City of Detroit
Inter-Departmental Communication

RE: Petition No. 162
Requested Encroachment Into Bagley At 415 Clifford With Entry and Window
Canopies And New Planters In The Block Bound By Bagley, Clifford,, Times
Square, And Grand River

NOTICE OF PROPOSED CHANGE IN PROPERTY

REQUEST ENCROACHMENT
 INTO BAGLEY
 AT 415 CLIFFORD
 (With Entry and Window Canopies
 and New Planters)

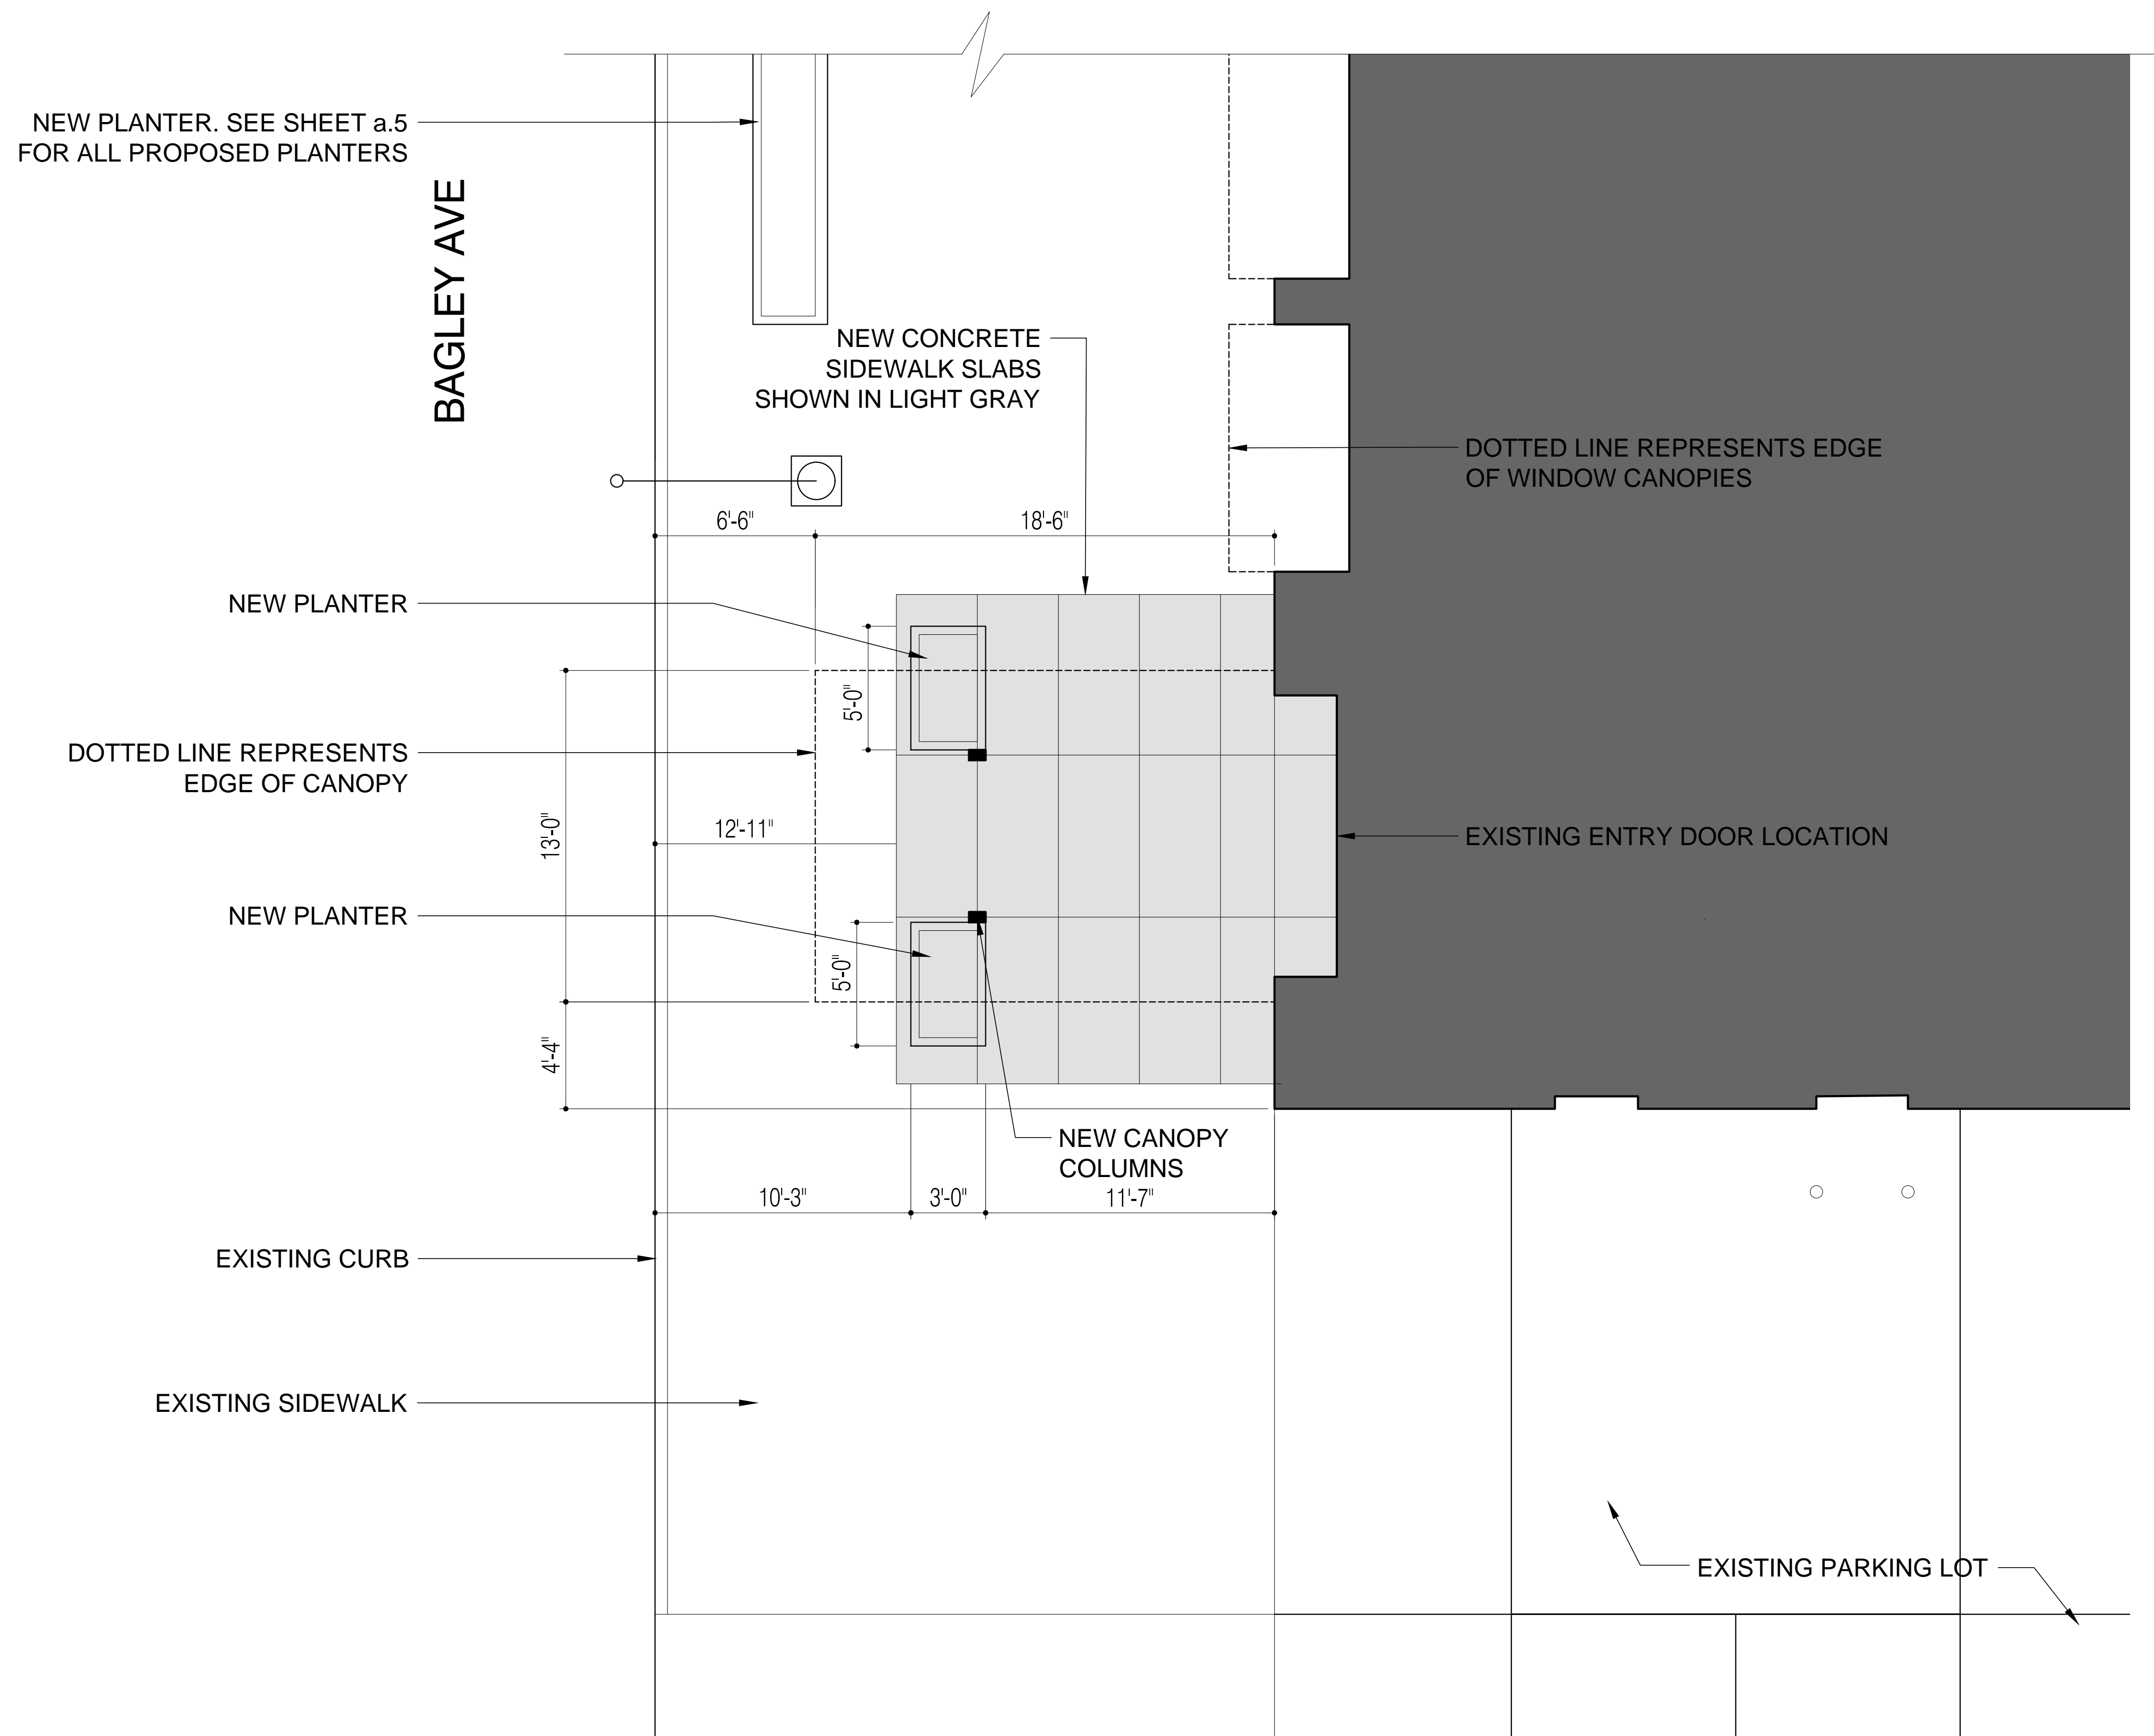
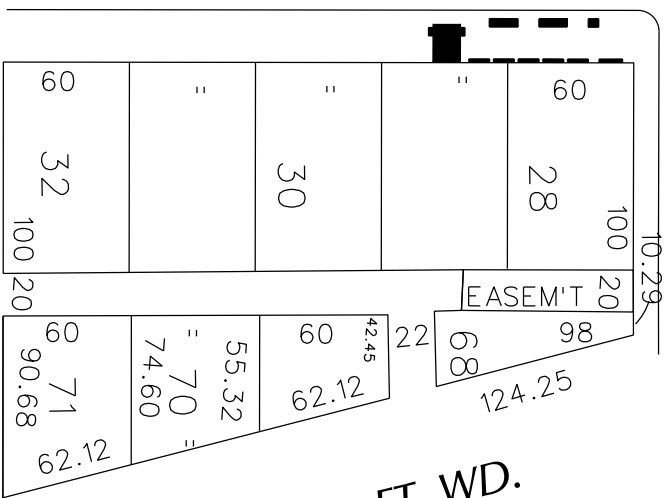
- DWSD has no objections to the requested encroachments provided that the attached Provisions for Encroachment are strictly followed.

2. DWSD requires a vertical clearance of 18 feet above grade for maintenance excess and repair.
3. All construction performed under this petition shall not be commenced until after five (5) days written notice to DWSD. Seventy-two (72) hours notice shall also be provided in accordance with P.A. 53 1974, as amended, utilizing the MISS DIG one call system.
